**AMENDMENTS TO THE DRAWINGS**

**REMARKS/ARGUMENTS**

**Fig. 1** Arrangement of System, Picture, Audio and Auxiliary Items in a Content Package on SDTI.  
RELATED ART

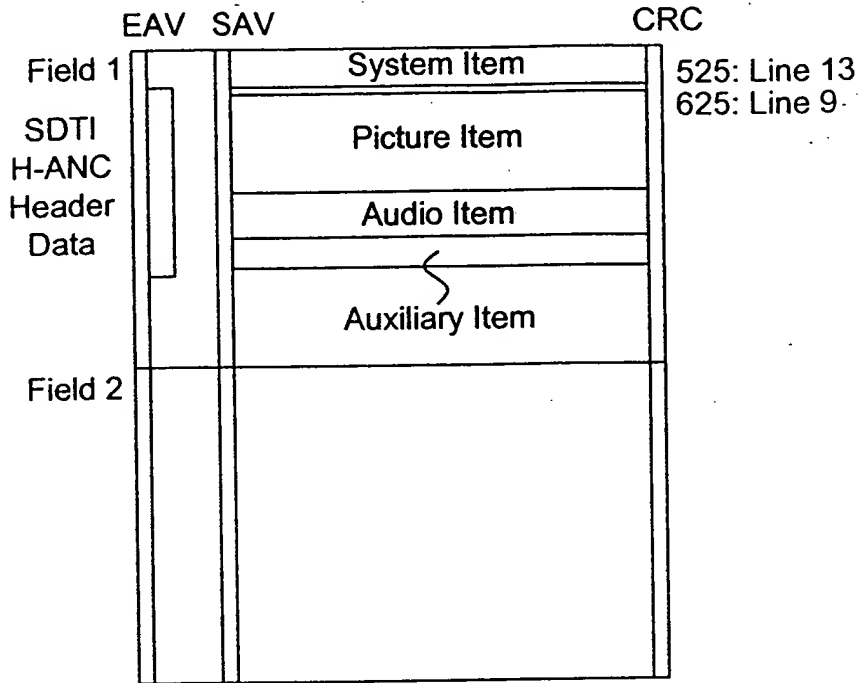
The attached two sheets of drawings include amendments to Figures 1, 2, and 3.

6. In Figures 1-3, the legend "Related Art" has been added.
